ZU1 Power Table

26	RTC BAT issue	Change RTC BATTERY CONN CN12(follow to ZC3)	A1A	14		
27	ICH8-M Strap issue	Stuff R241, no stuff R266 (Disable Internal VR powering VccLAN1_05, VccCL1_05)	A1A	14		
28	ICH8-M HDA issue	add R283,R465,R463,R267 for MDC module (base on Intel Design Giude)	A1A	14		
29	ICH8-M issue	PU RCIN# to +3V	A1A	14		
30	ICH8-M issue	Remove ICH8-M GLAN/SATA1/SATA2 circuit (no use)	A1A	14		
31	ICH8-M issue	change net name (U31/Pin2) from VR_PWRGD_CLKEN# to VR_PWRGD_CK410#	A1A	16		
32	ICH8-M issue	Remove SATACLKREQ#(U32/Pin:AG13),RI# (U32/Pin:AF17) ;{no use}	A1A	16		
33	ICH8-M issue	no support iAMT, remove SMB_CLK_ME,SMB_DATA_ME	A1A	16		
34	ICH8-M issue	change DOCKIN#_ICH_R PU from +3V to +3V_S5	A1A	16		
<div>PROJECT : ZU1 Quanta Computer Inc.</div>		PROJECT : ZU1	APPROVE BY : James Lu	DRAWING BY:Barry Lee	Stage: A1	CHANGE LIST SHEET 1
		MB ASSY'S P/N : 31ZU1MB0000	PROJECT LEADER:Jack Wu	DOCUMENT NO:	DATE :2006/12/09

Size	Document Number	Rev
	CLK. GEN./ CK505	3
Date:	Tuesday, April 10, 2007	Sheet 2 of 39

## CPU Clock select

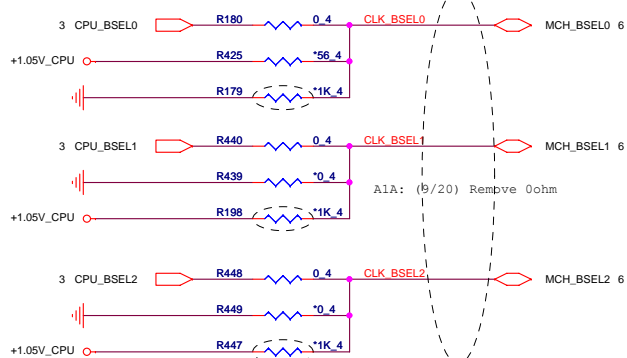
C2A: (12/10) no stuff R179,R198,R447 for auto CPU frequency selection (follow ZD1,Z01)

DDR2 Dual channel A/B CONN

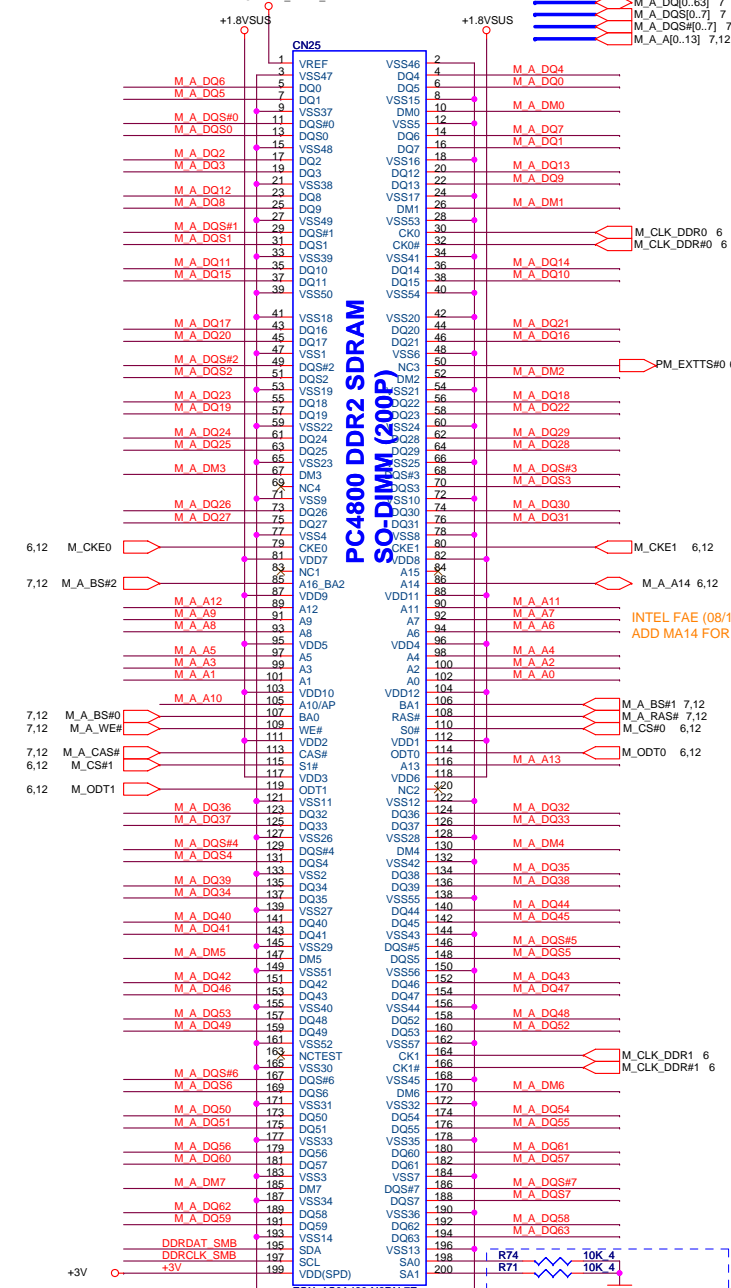
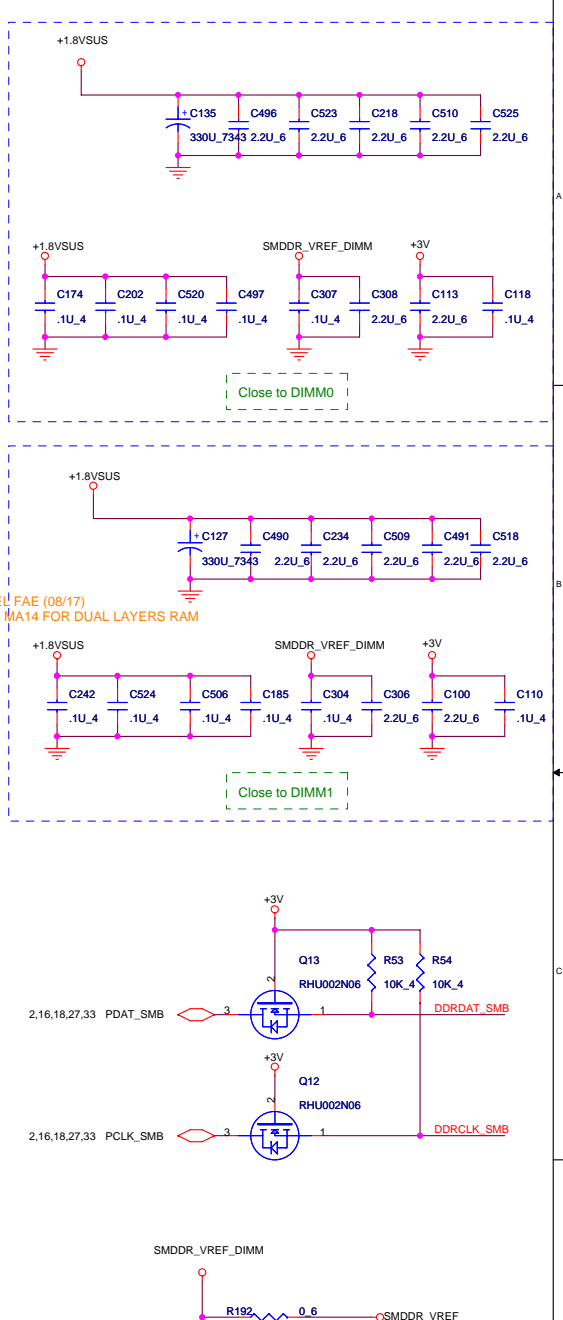
A1A: (10/30) no stuff R192, stuff R191,R193  
A1A: (11/09) stuff R192, no stuff R191,R193

## HDA

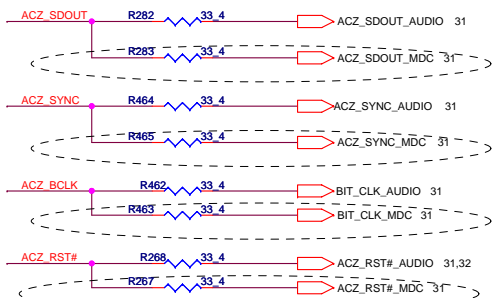
AlA: 9/6 base on Intel design guide, add it.

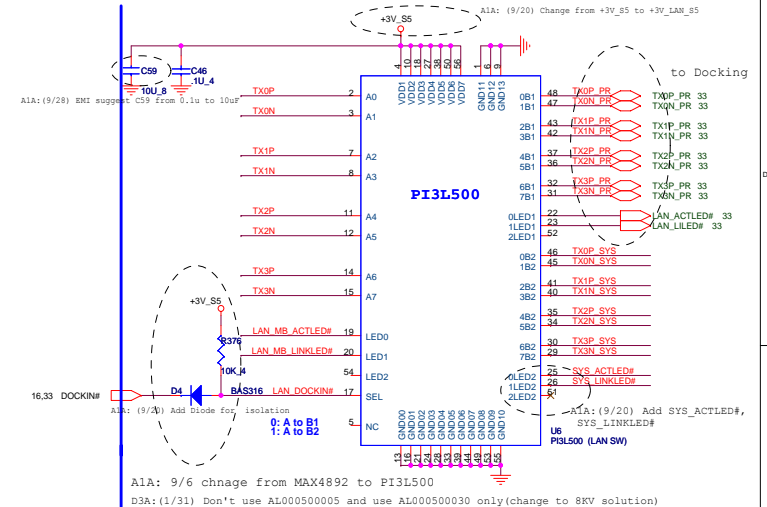
A1A: (9/1 BCM recommend)  
stuff R30, no stuff R47 (in order to pull up C90, C86 and Q16/pin 3 to  
3V LAN rail)

AlA: 9/6 chnage from MAX4892 to PI3L500

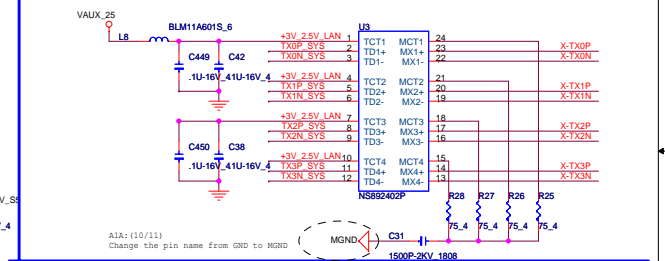
D3A:(1/31) Don't use AL000500005 and use AL000500030 only(change to 8KV solution)

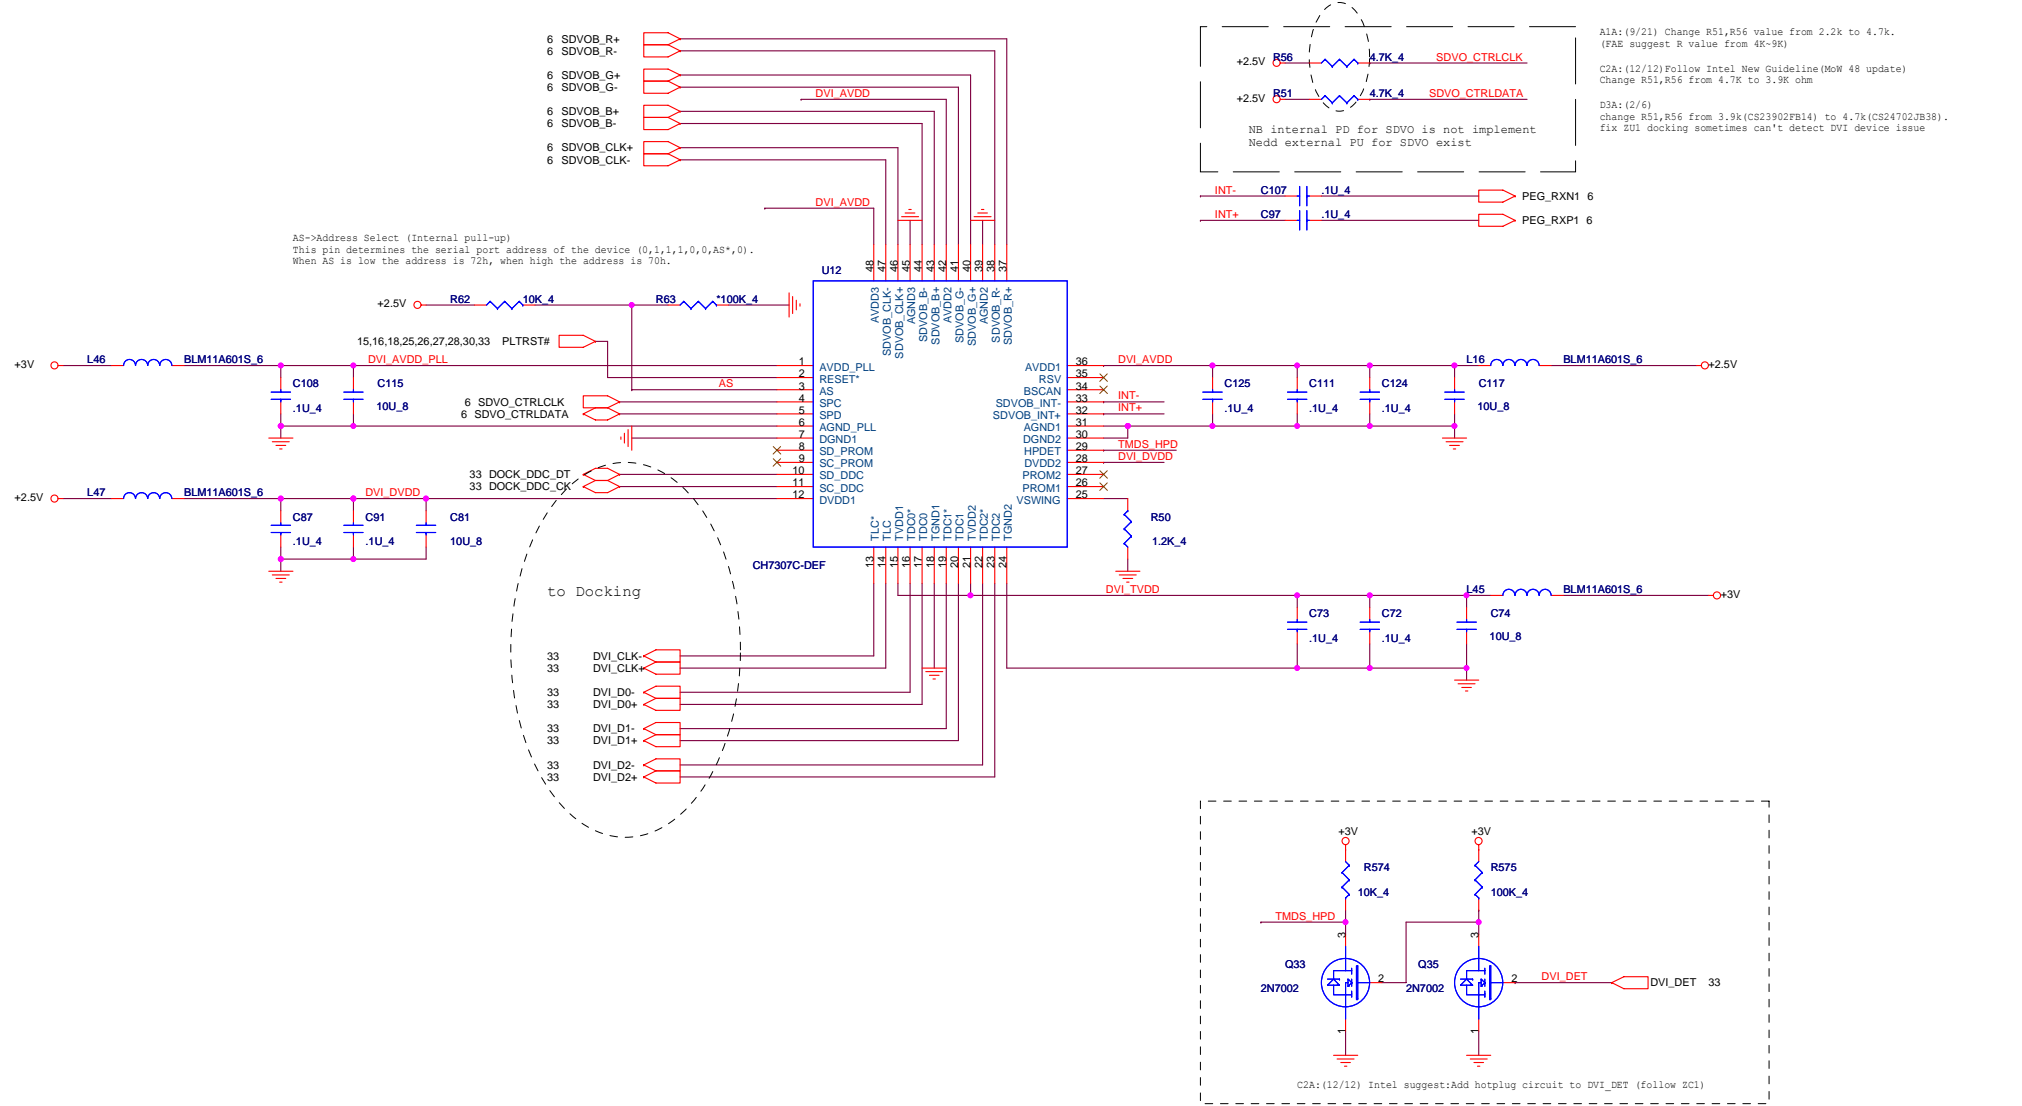
A1A: (9/21) Change R51,R56 value from 2.2k to 4.7k.  
(FAE suggest R value from 4K-9K)  
C2A: (12/12) Follow Intel New Guideline (MoW 48 update)  
Change R51,R56 from 4.7K to 3.9K ohm  
D3A: (2/6)  
change R51,R56 from 3.9k(CS23902FB14) to 4.7k(CS24702JB38).  
fix ZUI docking sometimes can't detect DVI device issue

D3A: (1/30) remove U13,R68,R75,R73,C98  
1/16 confirm with CHRONTEL FAE,  
he said we can remove CH9901 (U13),  
if ZUI need support HDCP,  
CH7313 already integrated HDCP function, no need external EEPROM.

## BLUETOOTH MODULE CONNECTOR

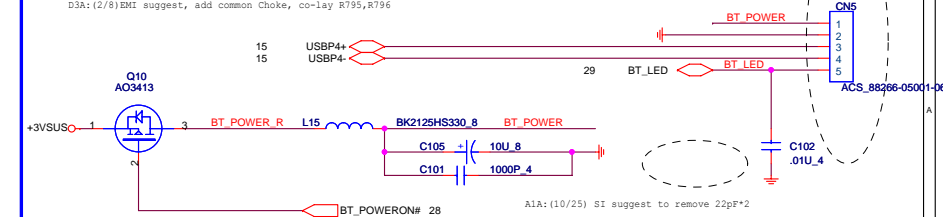
A1A: (9/25) change CONN (follow ZH3)

D3A:(2/8)EMI suggest, add common Choke, co-lay R795,R796

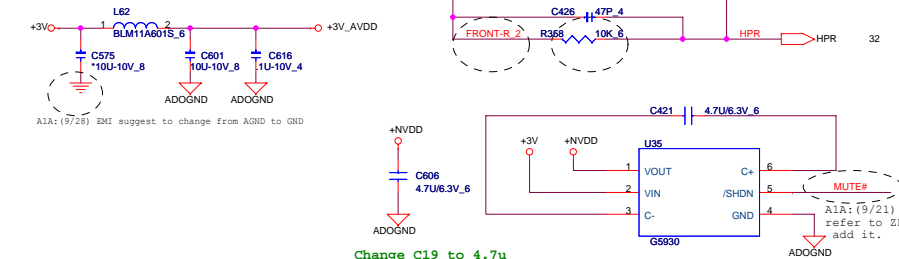
C2A: (12/25) no stuff R525,D41, add bypass R577 to solve pop sound issue

## MDC

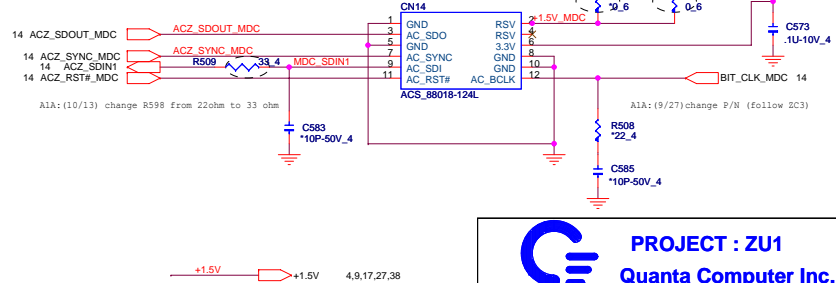
D3A:(1/21) Change CN14/pin 2 from +3v to +3v\_s5.  
Fix Modem wake from S3 fail issue.
